CHURCH's #695
- 5407 Central NW -

PAVING
DRIVEPADS

DWG. 2425

PLAN

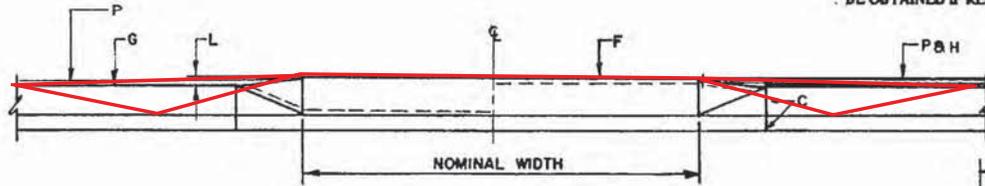
- Possible alternative driveway entrance, with flared ramp layout, and sidewalk pushed back into an easement on the property.

- You may be able to pull it all out into the R/W if R/W depth is adequate.
